Our reference 22-379-20

RE: CAEWERN HOUSE, HEOL ILLTYD, NEATH – LETTER OF RESPONSE

I am writing further to your Authority's Transport Development Services comments dated 28th October 2024 in respect of planning application 2/3/24/0301/00, which seeks permission for construction of 36 affordable residential flats...

Figure 3 Access Road – Distance to Parking Bays

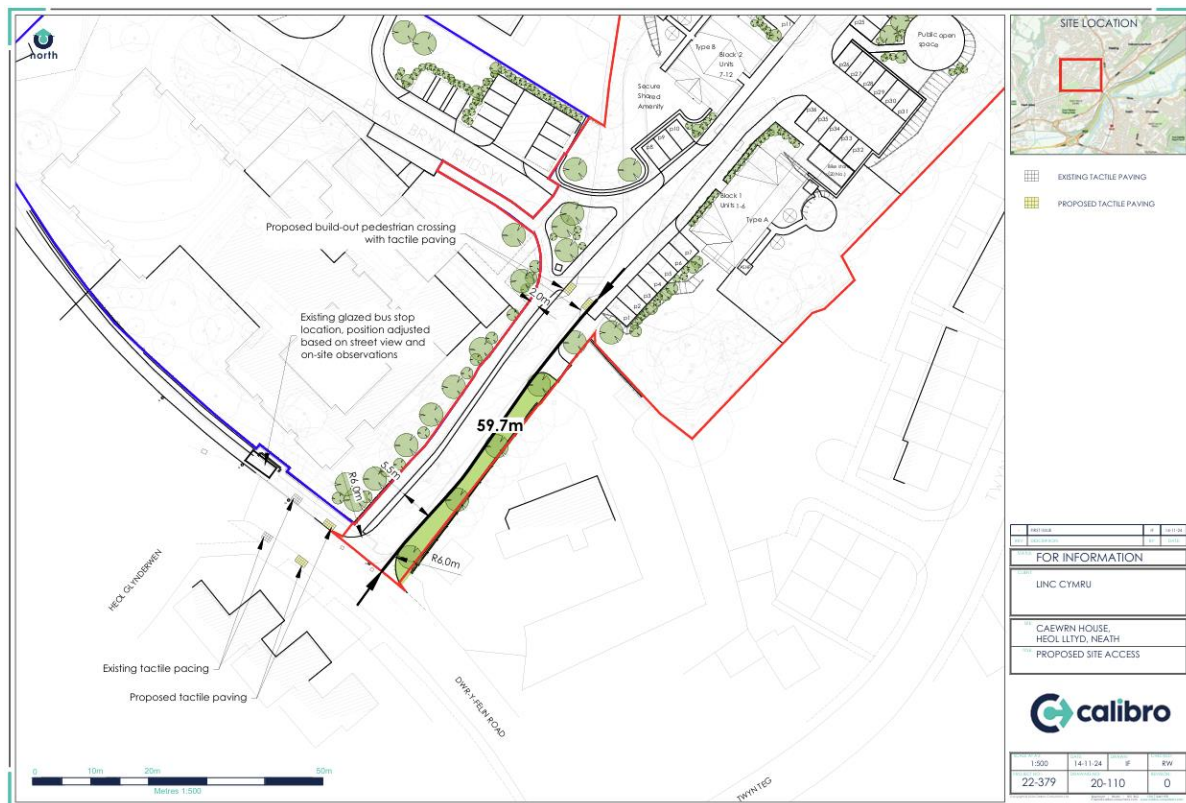
Comment 2: Unrestrained Highway Length

As noted within my observations the inclusion of the tactile crossing at 60m does not alleviate our concerns on the unrestrained length of highway. The unrestrained highway still appears to be 80m as the parking bays will be accessed from vehicular crossovers. This will need to be considered to ensure that vehicular speeds are not encouraged to be in excess of the design limit.

In response, we propose to provide a kerb build out at the crossing – narrowing the carriageway for a short section to 3-metres. The proposals are provide within Figure 3 below, whilst a scale version 3 is provided at [Appendix B](#) of this letter.

Figure 4 On site Intervisibility

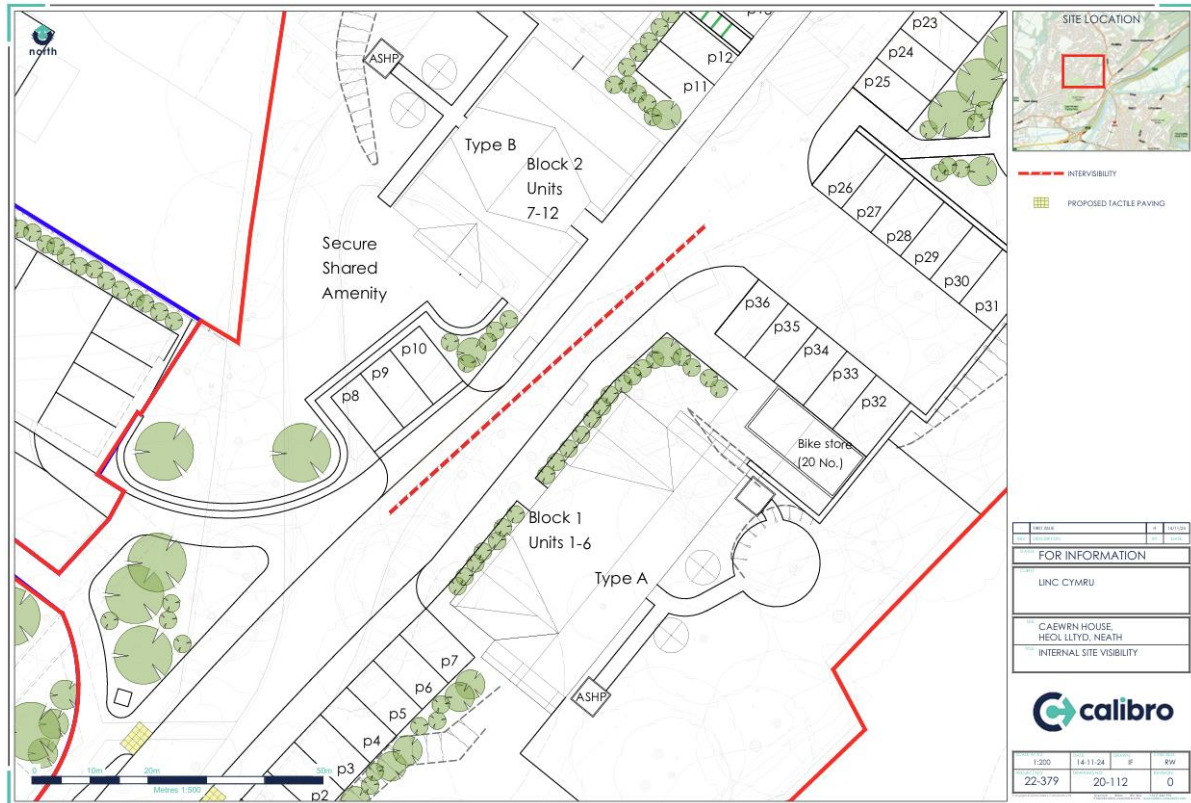
Comment 3: Road narrowing

On the 'Proposed Site Plan' Revision J, the narrowing is still in excess of the maximum 10m in length.

In response to Comment 3, it is evident that suitable intervisibility between both directions of travel is afforded in order to manage the space safely and efficiently, as shown within Figure 4 below, with a scale version provided at [Appendix C](#).

Beyond the above, as shown within the submitted Transport Statement the peak vehicular flows are 10 and 8 two-way movement within the morning and evening peak hours respectively, which equates to a movement every 6 minutes at most. Noting that with the layout of parking proposed some 25% of those trips are likely to be to/from the 10 car parking spaces to the south, the chances of vehicles meeting each other over such a distance would be minimal and as shown with the intervisibility above would be avoidable and may only require a short waiting period for a manoeuvring vehicle to clear the area in question.

TITLE: VISIBILITY SPLAYS

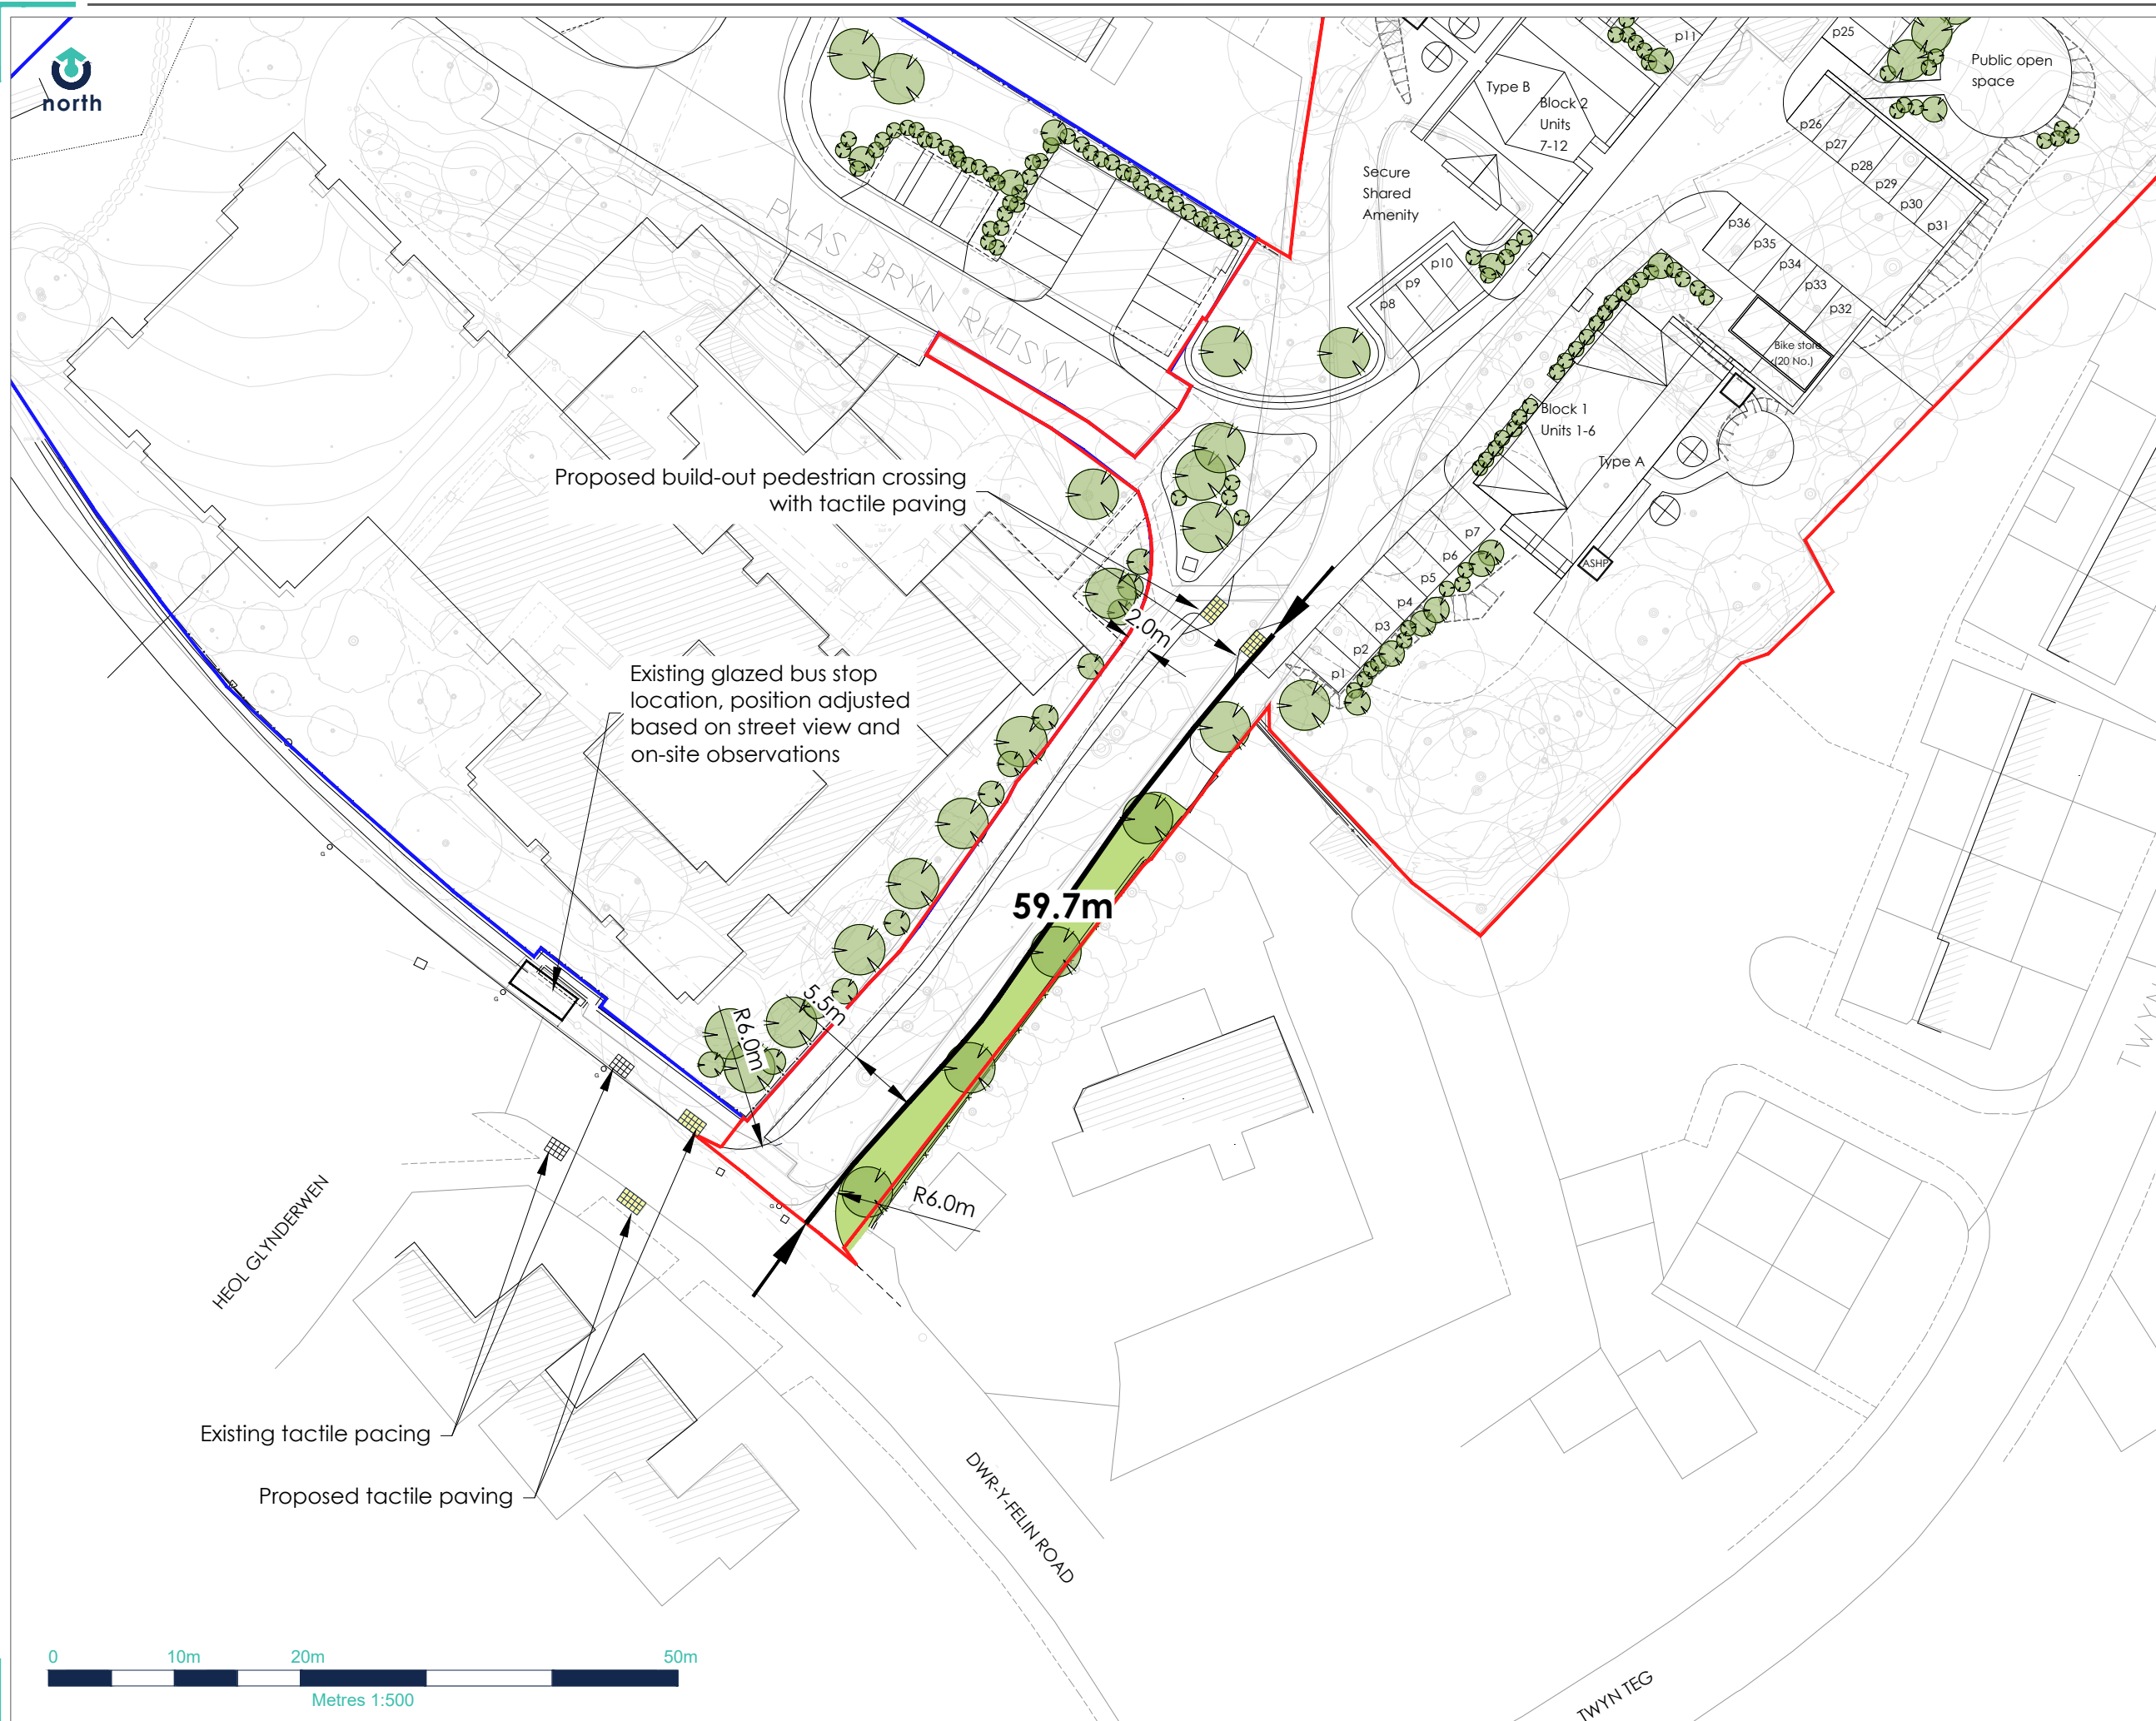
Comment 1: Visibility Splays

In regards to visibility splays, we require 2.4m x 25m onto Dwr Y Felin Road as this is an unclassified 20mph highway. On the visibility splays drawing it is difficult to see where the existing kerb line in front of the bus shelter is located, it states within the screenshot provided that the splay is not drawn correctly on the current drawing. As shown on the extract below, Manual for Streets does not allow for the acceptance of an offset from the channel line, please find an extract from Manual for Streets below. Therefore, the current drawing suggests that the bus stop would need to be moved to ensure suitable vehicular visibility splays (and a drawing detailing this to be provided, cross-referencing the information in the TS).

In response to the above, we have sought to produce a visibility splay drawing utilising topographical data. The provision of the required 25-metre visibility is shown in [Figure 1](#) below and has been provided at to scale under [Appendix A](#) of this letter. With this, it can be seen that the achievable visibility to the kerbline does not pass through the bus shelter – which has been positioned in line with the topo survey and Google Streetview - shown in [Figure 2](#) below, which clearly shows the position of the bus shelter set back from the carriageway edge.
